Discussion about forward  
RICH space in ATHENA

# Original dRICH design (JLEIC legacy)

# Trying to fit it within the envelope (Detector Menagerie)

**this is the original dRICH design (JLEIC legacy)**

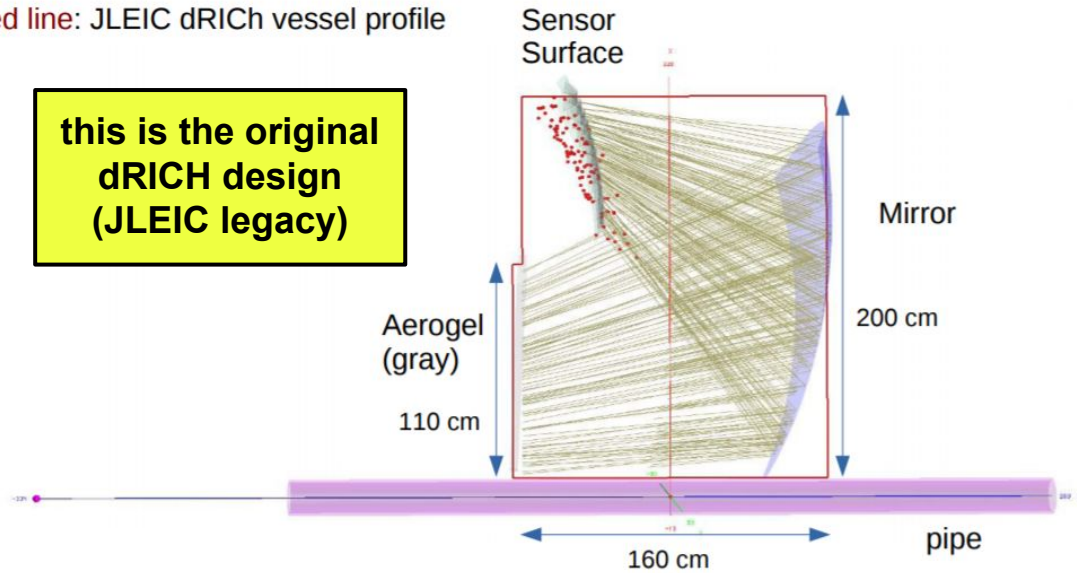
sensor surface ~ matches location of focal plane but it does not fit in the forward RICH envelope that appears in the Detector Menagerie (the alternate version with DIRC readout on the e- side)

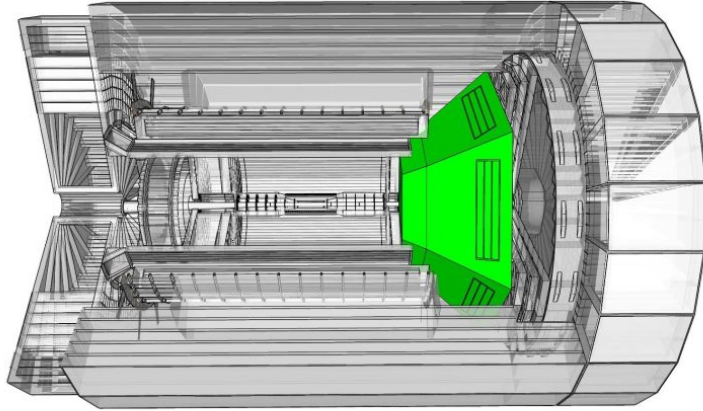
very difficult (impossible?) to adapt the sensor surface to the focal region

**Dynamic RICH**

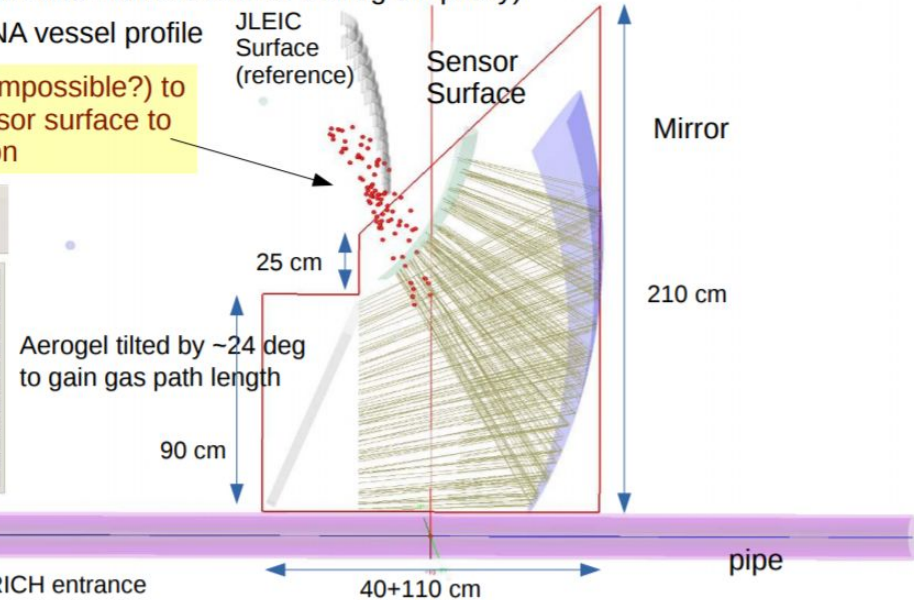
attempts to adapt the dRICH elements (mirror, sensors) within the envelope cannot find enough space to properly locate the sensors on (or near) the focal plane

available dRICH space,  
Menagerie 3T  
DIRC LD readout

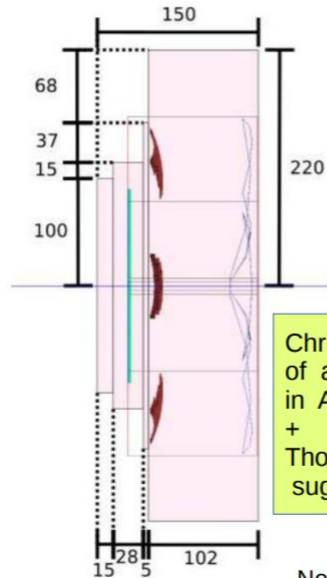
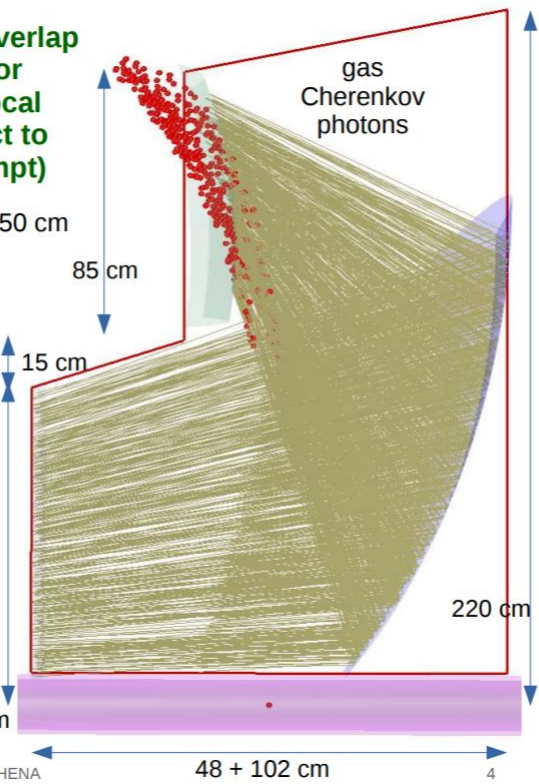
Much better overlap  
between sensor  
surface and focal  
region (respect to  
previous attempt)

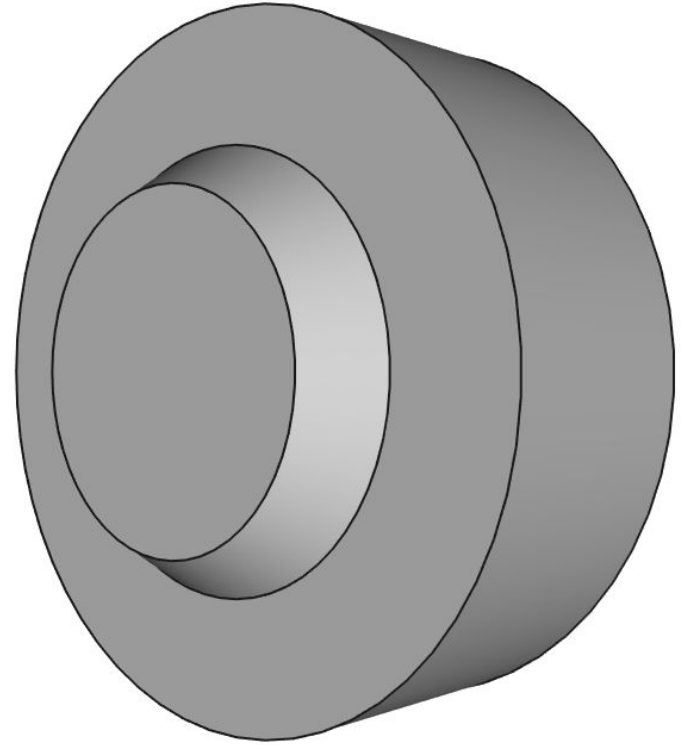
hole for beam  
pipe is missing

single mirror  
configuration

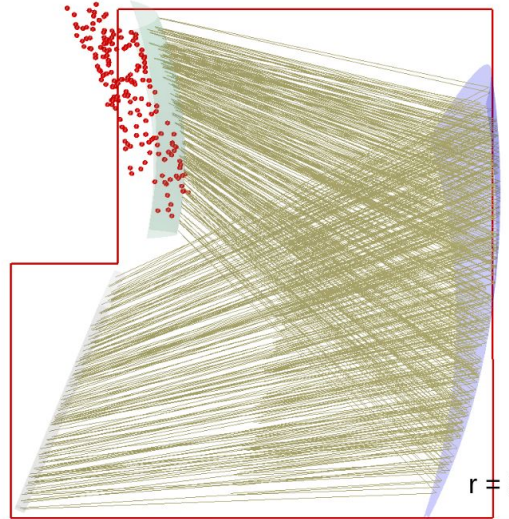
sensor surface ~ matches location of focal plane  
but it does not fit in the forward RICH envelope  
that appears in the Detector Menagerie (the alternate  
version with DIRC readout on the e- side)

There is much more margin of improvement  
(than previous geometry) thanks to the  
transverse available space, in the back vessel.  
Possible directions:

- tune mirror radius, its rotation, the sensor position
- use double reflections scheme with sensor above mirror
- use segmented mirrors with different radii of curvature
- ...

4 mirror segments

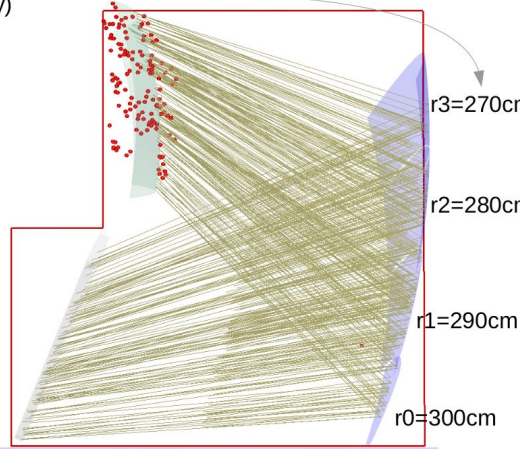
the sensor surface can better  
match the focal region  
than in single mirror  
configuration
